Pittsburg Tank & Tower Maintenance Co., Inc.®

**Veterans Administration
2121 N. Avenue
Grand Junction, CO 81501
RE: Boiler House
100,000 Gallon E.W.T.
May 17, 2013
Doyle Payne,
Assistant Chief Engineering Service
(970) 242-0731 ext. 2099
Job No. 313195**

ELEVATED TANK INSPECTION REPORT

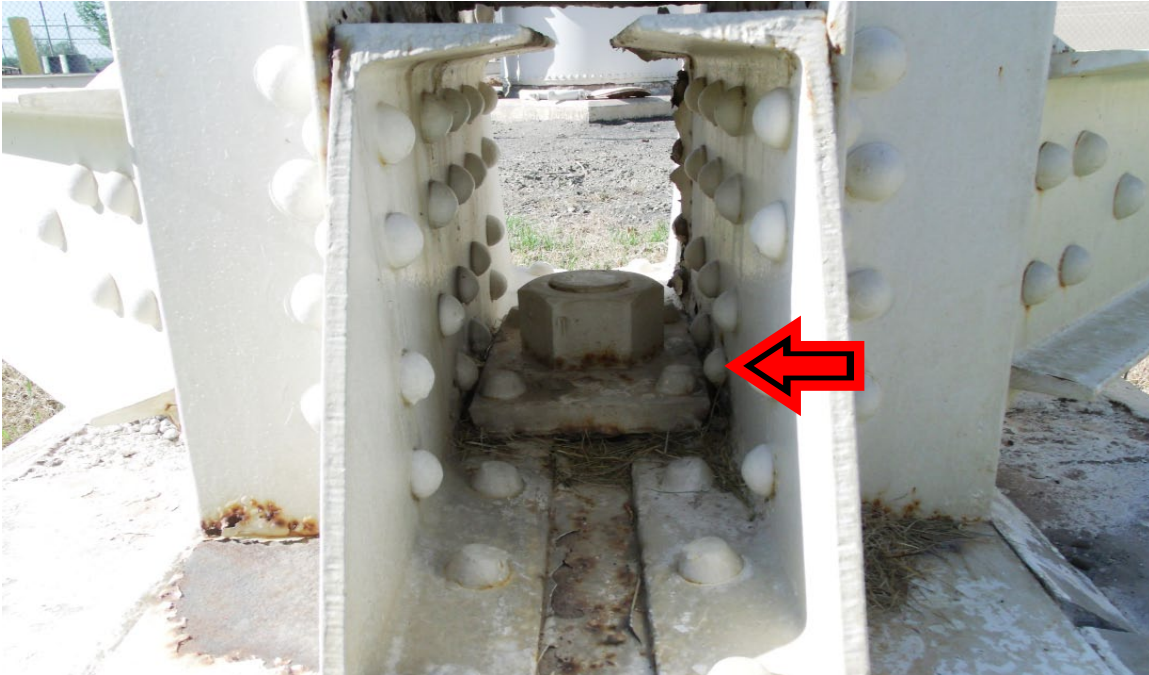
Photo shows the condition of the foundations. We recommend removing all dirt, debris and loose gravel from the foundation, repairing any cracks and spalling in the concrete with a commercial non-shrinking grout and sealing the foundation with a sealant.

We also recommend the tank be electrically grounded for lightning protection as required by [OSH Act 29 CFR 1926, Subpart K](#).

2. Repair any cracks and spalling in the concrete with a commercial non-shrinking grout and seal the foundations with a sealant

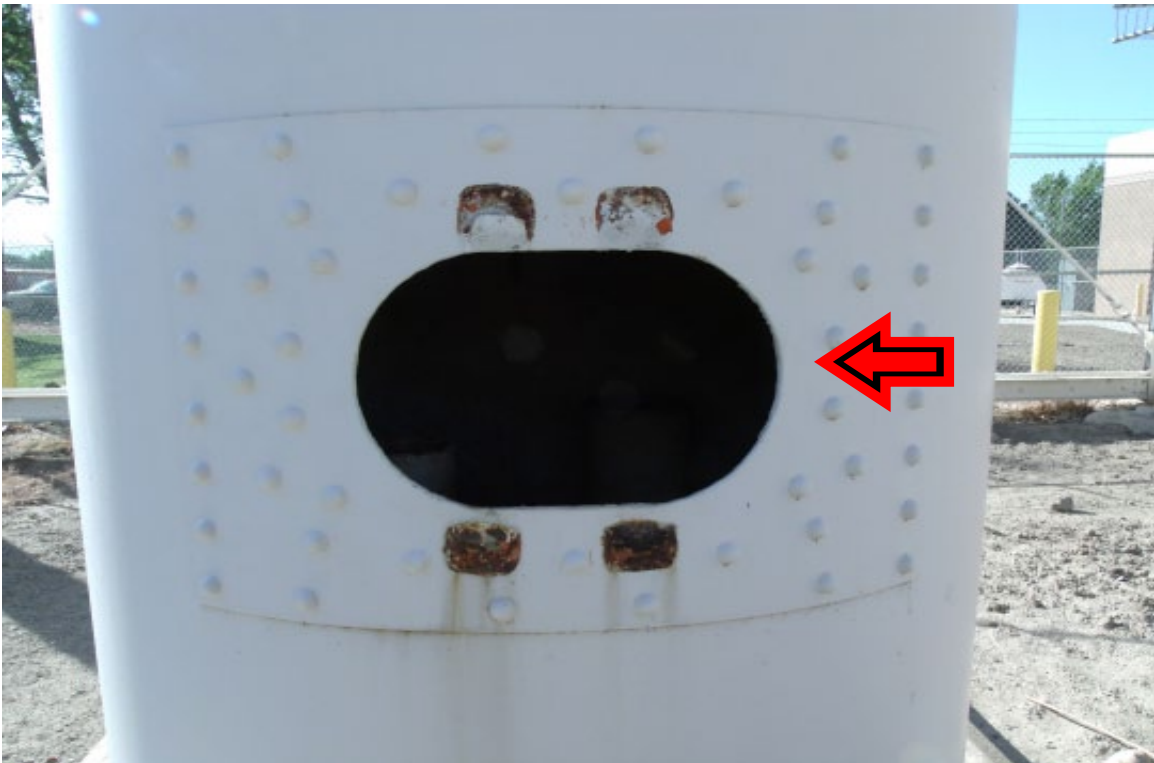
Photo shows the condition of the riser manway. This manway would restrict entry in an emergency. We recommend replacing the existing riser manway with an **AWWA D100-11: 5.4.4** approved 24" manway, complete with a davit arm, a **Confined Space Entry** sign and maintenance free galvanized steel bolts.

6. Replace the existing riser manway with an, approved 24" manway, complete with a davit arm, a **Confined Space Entry** sign and maintenance free galvanized steel bolts

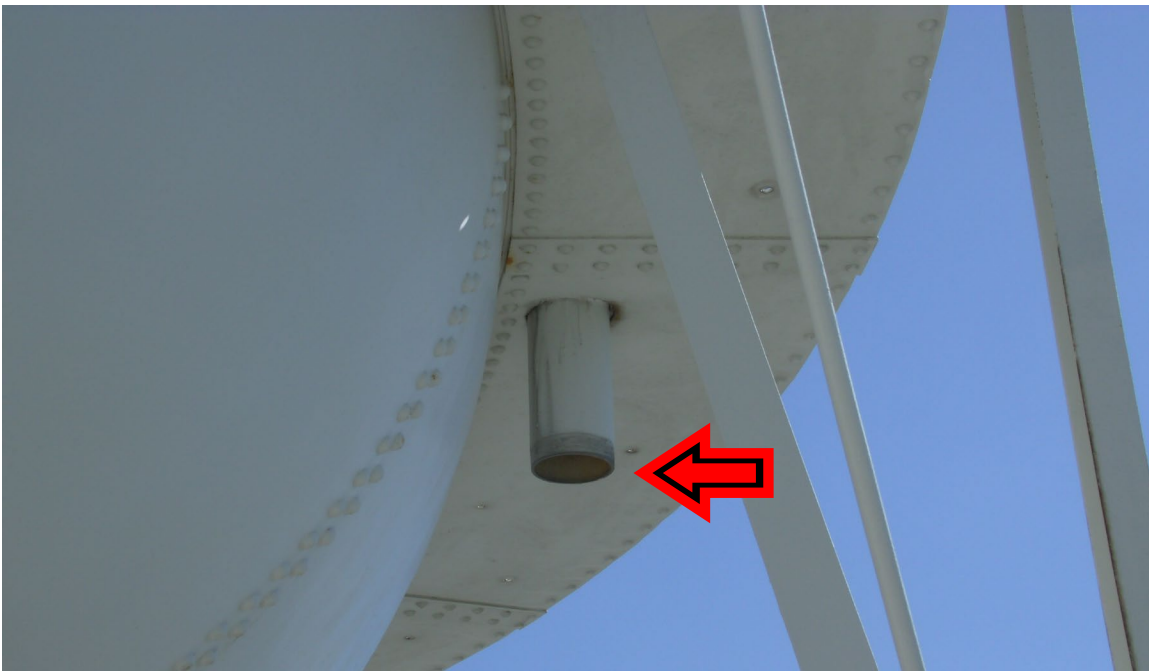
Photo shows the inlet and outlet pipes in the base of the riser pipe. We recommend installing a protective plate over the outlet pipe, supported over the pipe by three 1/2" x 1" standoffs 12" long. This will prevent silt from falling into the pipe from the tank bowl.

7. Install a protective plate over the outlet pipe located in the riser
8. Extend the overflow down the exterior to grade, complete with stand-offs every 12' on center, install an elbow, a flapper valve with a screen and a splash pad

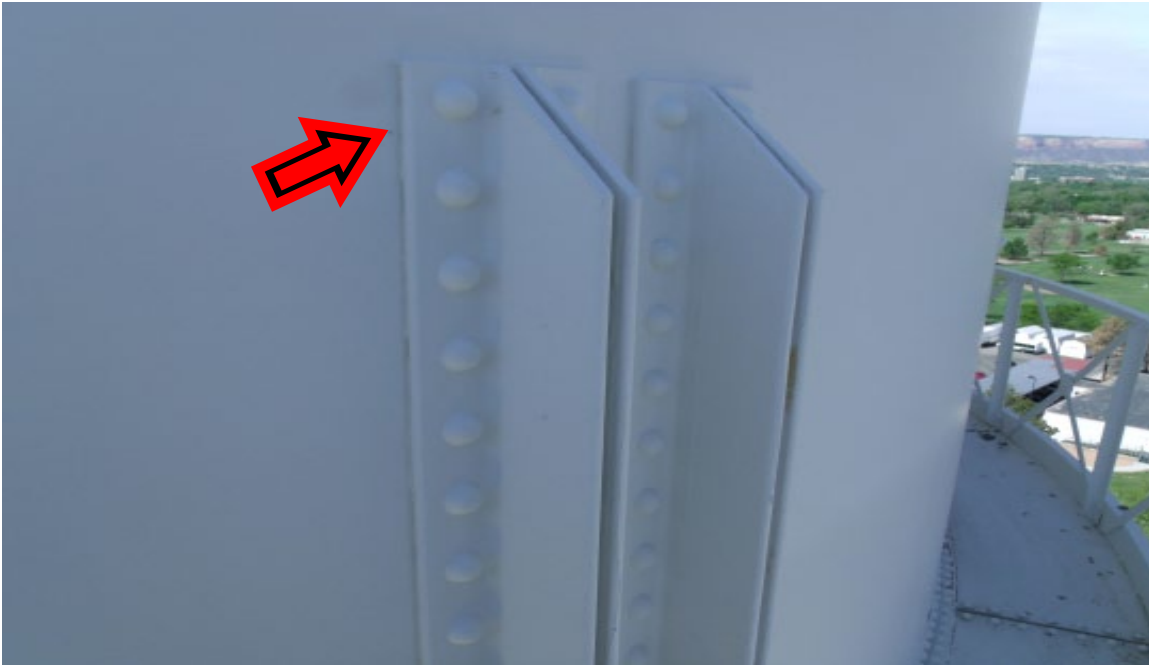
Photo shows the condition of the tank shell. Shell manways installed on this tank will be in compliance with **AWWA D100-11; 7.4.4** and **OSHA 1910.36**; General requirements.

We recommend :

- Install a 30" shell manway
- Install a 30" second shell manway 180° from primary shell manway
- Post **Confined Space Entry** signs at shell manways
- Install interior bowl ladders at shell manways
- Install cable type ladder safety devices on interior bowl ladders

15. Drill additional weep holes in balcony floor
16. Install a 30" shell manway
Install a 30" second shell manway 180° from primary shell manway
Post **Confined Space Entry** signs at shell manways
Install interior bowl ladders at shell manways
Install cable type ladder safety devices on interior bowl ladders

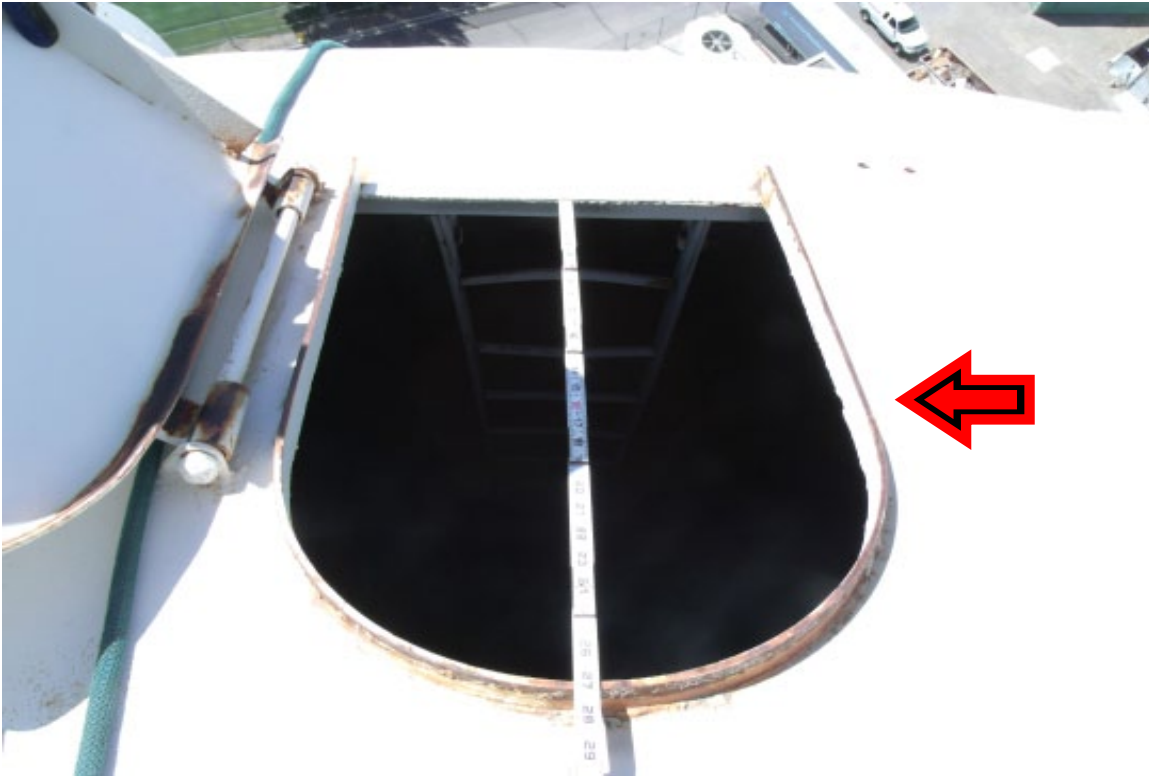
Photo shows the condition of the 27" x 19" roof manway. Roof openings on this tank require the following to be in compliance with [OSHA 29 CFR 1910.23\(a\)\(1\)](#) and [AWWA D100-11; 5.4.3.1 roof openings](#).

We recommend:

- Replace existing roof manway with a 30" manway with a 4" curb and a 2" overlap cover
- Post a **Confined Space Entry** sign on roof manway
- Install handrails around all roof openings

21. Replace existing roof manway with a 30" manway with a 4" curb and a 2" overlap cover
Post a **Confined Space Entry** sign on roof manway
Install handrails around all roof openings

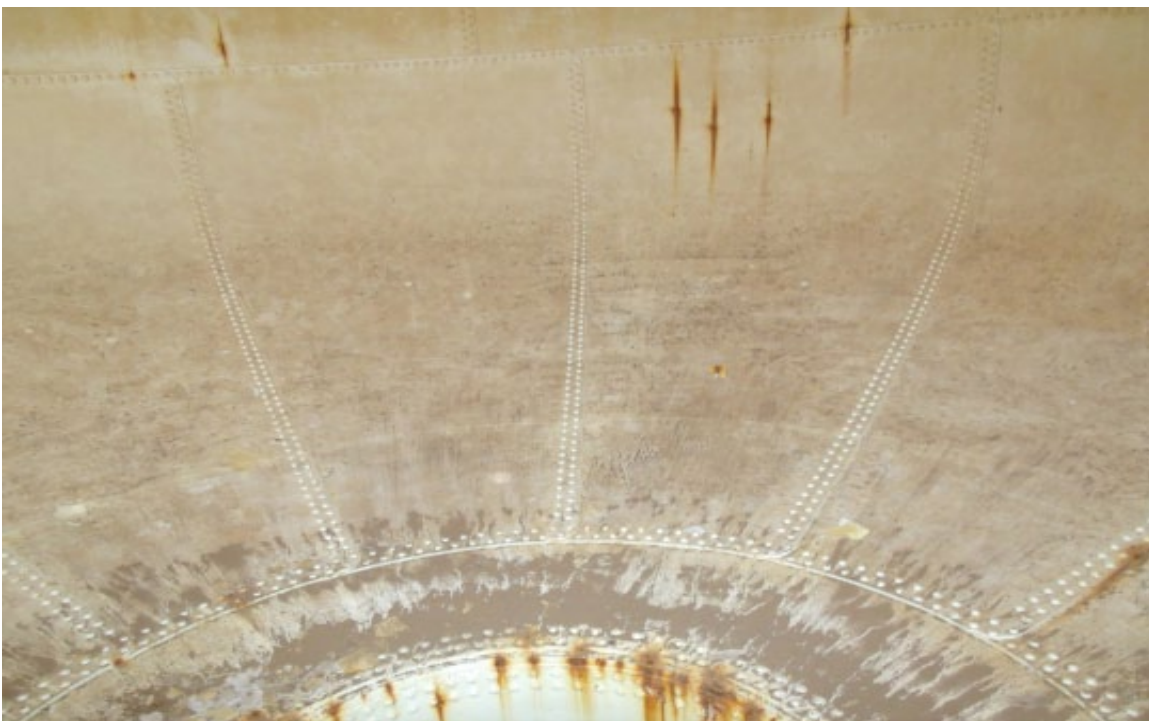
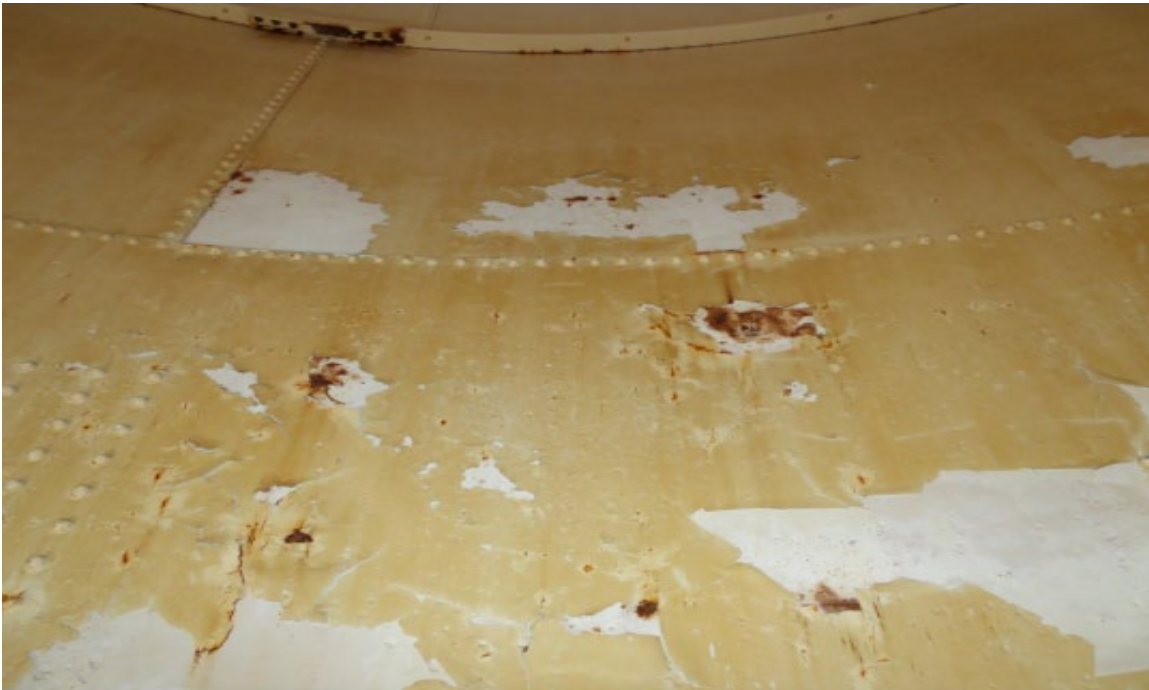
Photos show the interior access ladder is equipped with anti-skid rungs but is only 13" wide. (Also notice the bent rungs) **OSHA 19.27 Ladders** states; "Minimum clear distance between the sides of individual rung/step ladders and between the side rails of other fixed ladders must be 16 inches (41 cm)." We recommend installing an approved interior access ladder complete with standoffs every 12' on center and a cable type ladder safety device.

22. Replace the existing roof vent with a vacuum/pressure vent and screen
Repair or remove the obstruction light system
24. Install an approved, anti-skid rung equipped, interior access ladder complete with standoffs every 12' on center
Install a cable type ladder safety climb device
